Project: IEEE P802.15 Working Group for Wireless Personal Area Networks (WPANs)

Submission Title: [Resolutions to MR-FSK Comments on Modulation Quality]

Re: [MR-FSK Modulation Quality Proposal]

Purpose: [802.15.4g Comment Resolution for LB51.]

Limits – 2 Level FSK

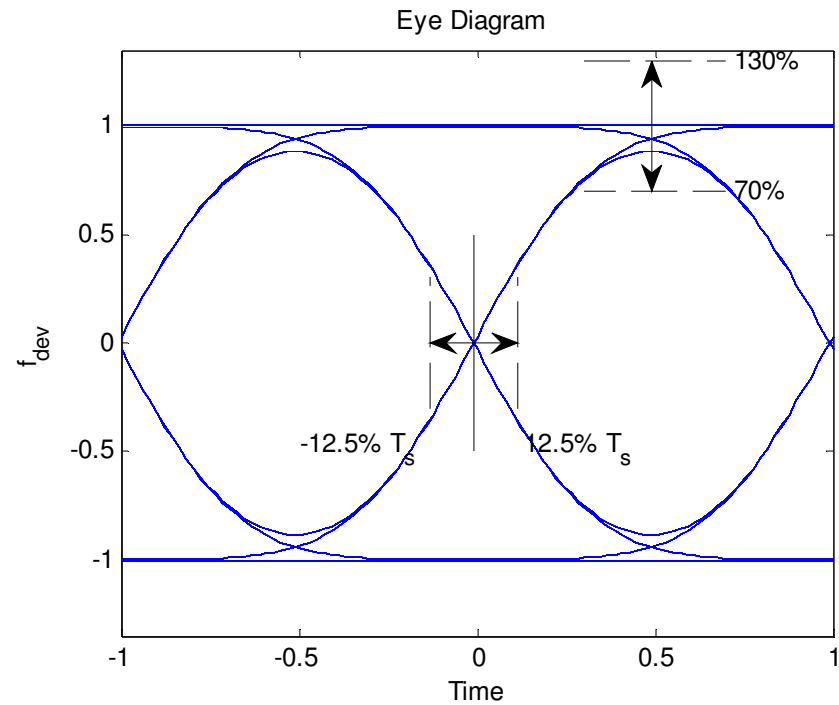
- Eye diagram shown for 2 level GFSK, $bt=0.5$
- Zero crossing tolerance
 - $\pm 1/8$ 'th symbol
- Frequency deviation tolerance
 - Allow $\pm 30\%$
 - Then $70\% f_{dev} < |f| < 130\% f_{dev}$

In the case of 2 level the measured frequency deviation, f , at $T_s/2$ shall be constrained to the range $70\% f_{dev} < |f| < 130\% f_{dev}$ as shown in fig 1.

In the case of 2 level the excursions for the zero crossings for all trajectories of the eye diagram shall be constrained to within $\pm 12.5\%$ of the symbol time T_s as shown in Fig 1.

Limits – 4 Level FSK

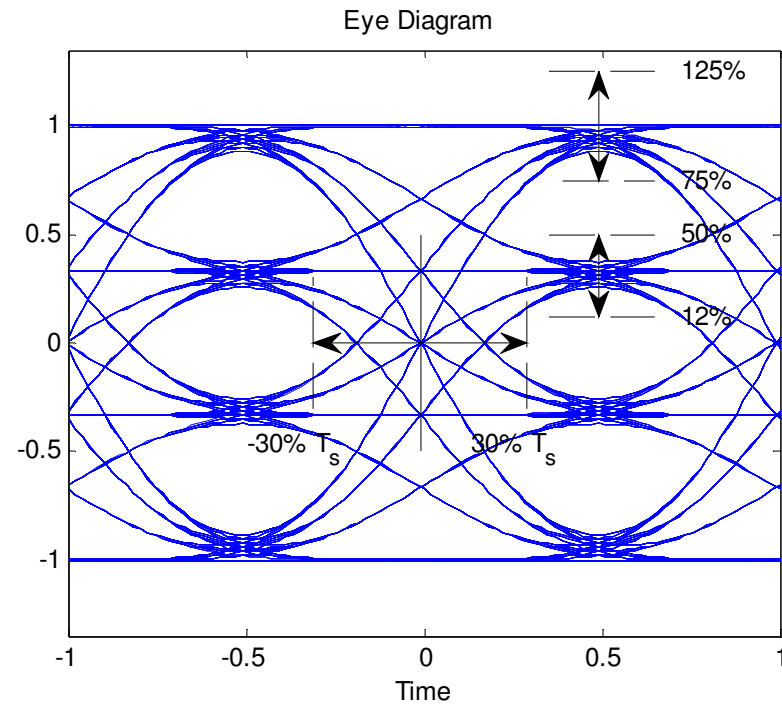
- Eye diagram shown for 4 level GFSK, bt=0.5
- Zero crossing tolerance
 - +/-30% symbol
- Frequency deviation tolerance
 - Then $12\% f_{dev} < |f| < 50\% f_{dev}$
 - And $75\% f_{dev} < |f| < 125\% f_{dev}$

In the case of 4 level the measured frequency deviation, f , at $T_s/2$ shall be constrained to the range $12\% f_{dev} < |f| < 50\% f_{dev}$ for the inner levels, and $75\% f_{dev} < |f| < 125\% f_{dev}$ for the outer levels as shown in fig 2.

In the case of 4 level the excursions for the zero crossings for all trajectories of the eye diagram shall be constrained to within $\pm 30\%$ of the symbol time T_s as shown in Fig 2.
